Questions to be answered on Barrel ECal

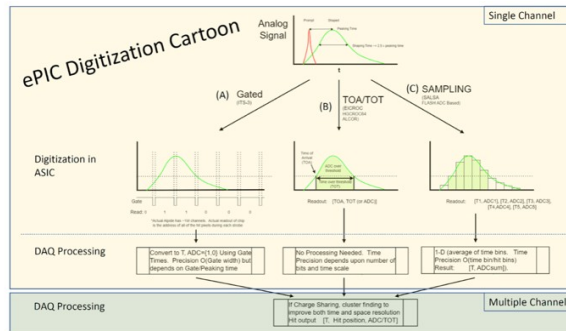
- Inner radius 78.25 cm → fixed
- Total length: in model right now 435 cm this does not guarantee any good overlap with backward ecal and forward Ecal, see figures below. In such a configuration the particles would only go through the imaging part.

To have overlap in both direction with the EEECal and fECal by at least one block one needs to increase the length of the bECal

- In electron going direction: 38 cm
- In hadron going direction: 15 cm
- total length 295 cm + 192 cm = 487 cm

→ this numbers need to be verified by simulations

- What will the depth of the calorimeter be, can we reduce it to 18 radiation length
- What is the combined response to neutrals (n , K_L) and muons from the outer HCal and bECal
- impacts also the discussion above on the total length.
